Consumer Product Service
Manager of Technical Support
UPGRADE BULLETIN

MODEL: ATARI 400/800 COMPUTERS

GTIA Chip

Revision B, Operating System ROMs.

CPU Board Silkscreen

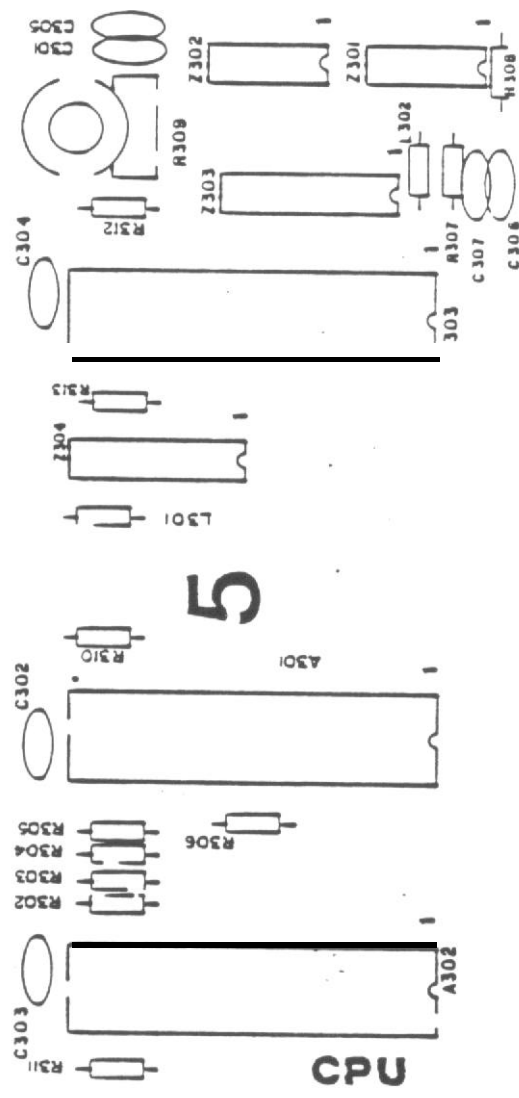
New units manufactured by Atari contain the Graphic Television Interface Adapt (GTIA) chip on the CPU printed circuit board. The GTIA chip is an enhancement of the Color Television Interface Adapter (CTIA) chip and may be purchased as an upgrade to existing units.

Part Location - CPU printed circuit board location A301.

Remove CO12295 from location A301 on CPU printed circuit board.

Install CO14805 in location A301 on CPU printed circuit board.

400 Motherboard Silkscreen

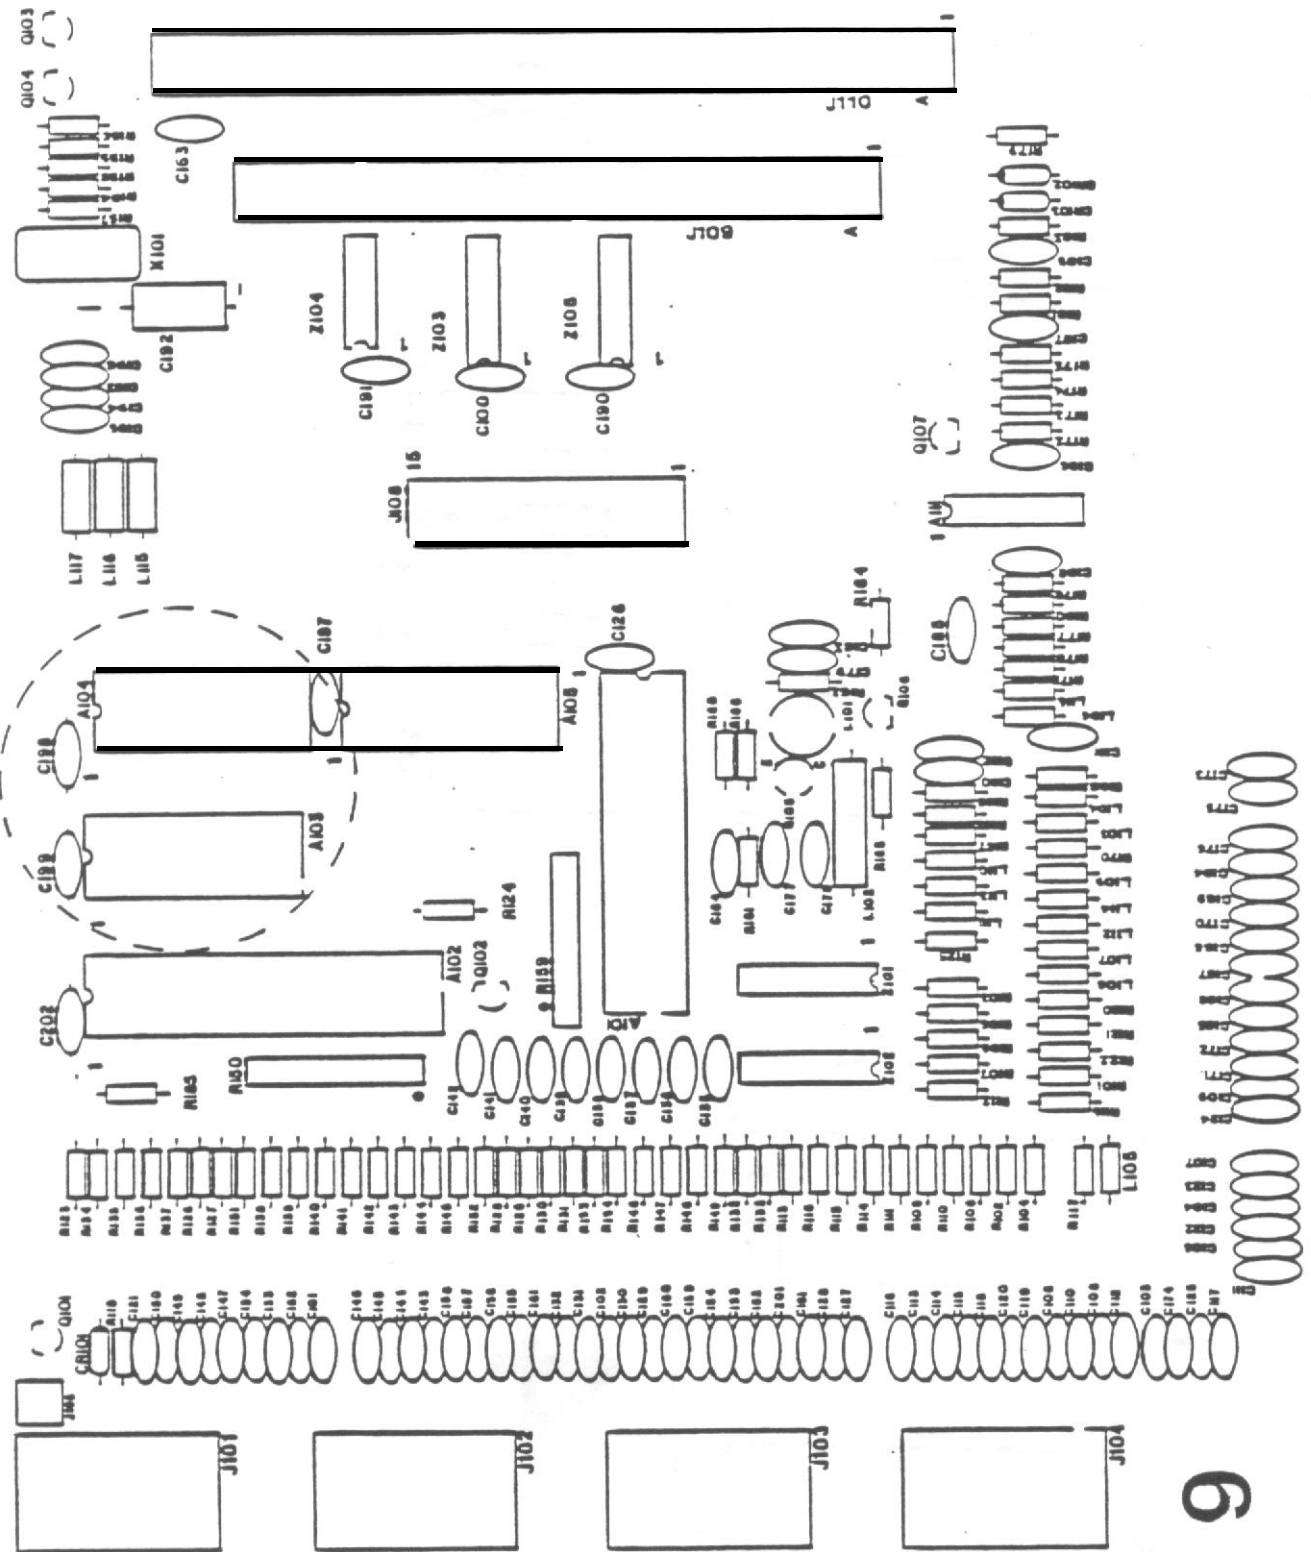
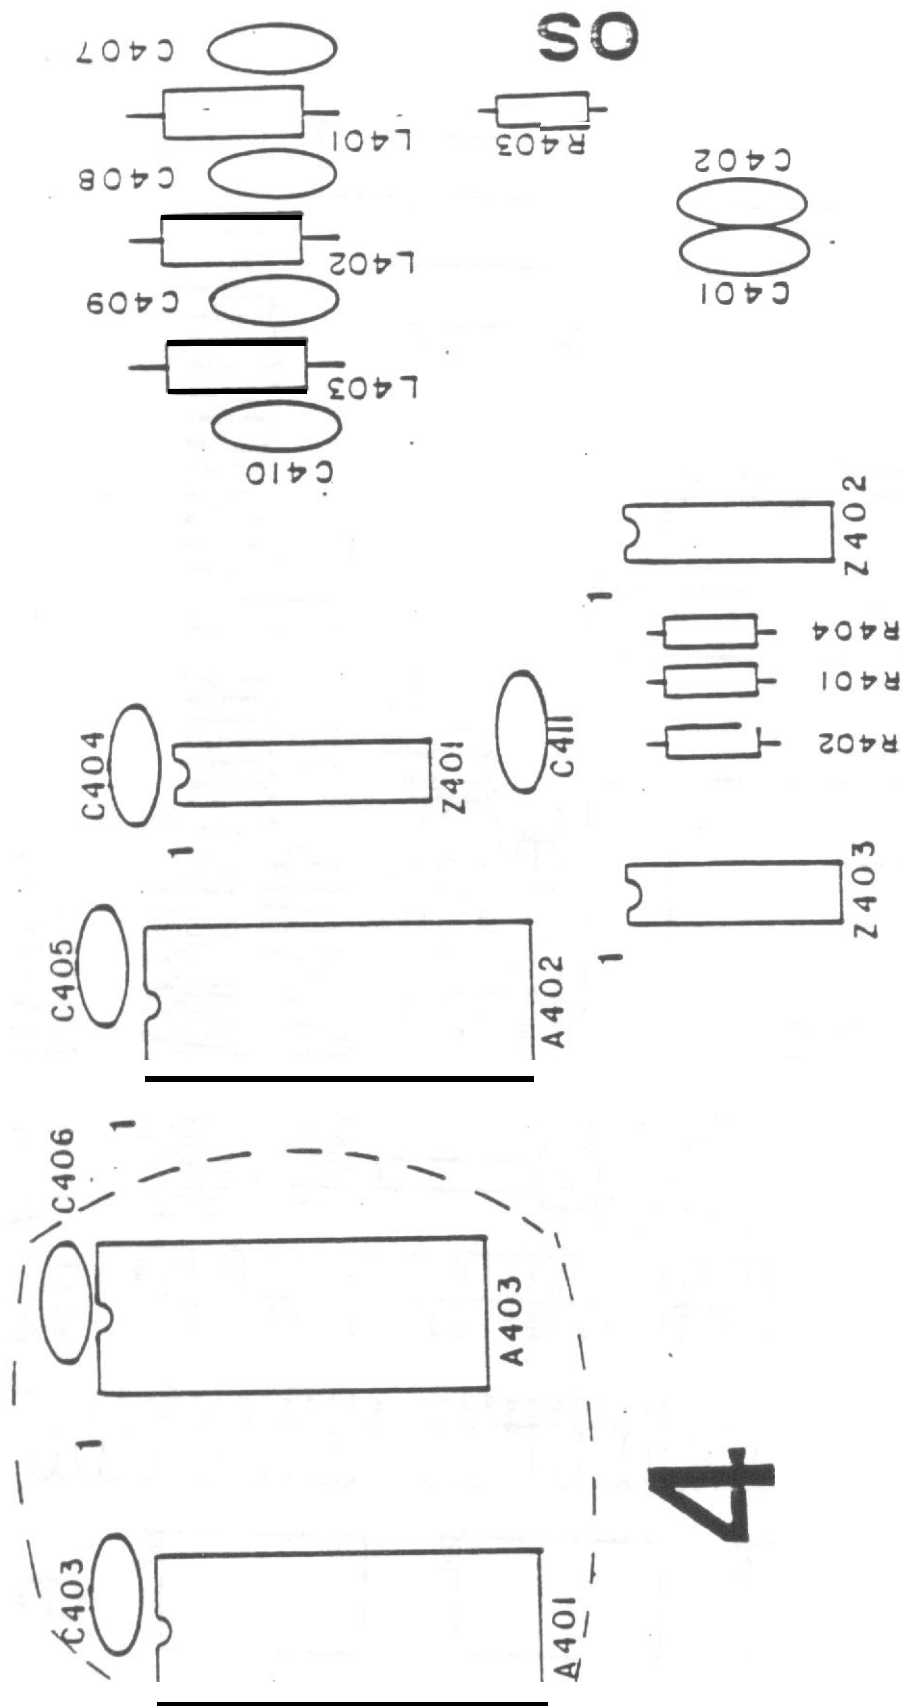
New Atari 400/800 computers contain Revision B ROMs — a refined version of an Operating System ROM, which has a different checksum from Revision A ROMs. When replacing these components, do not mix revision levels. System will not operate if Revision A is paired with Revision B.

400 Computer System - Motherboard location
A103 (C014599) and A104 (C012499)

Remove ROM chips located at A103 (C014599A) and A104 (C012499A).

Replace C014599A and C012499A with A103 (C014599B) and A104 (C012499B).

Replace C014599A and C012499A with A401 (C014599B) and A403 (C012499B).
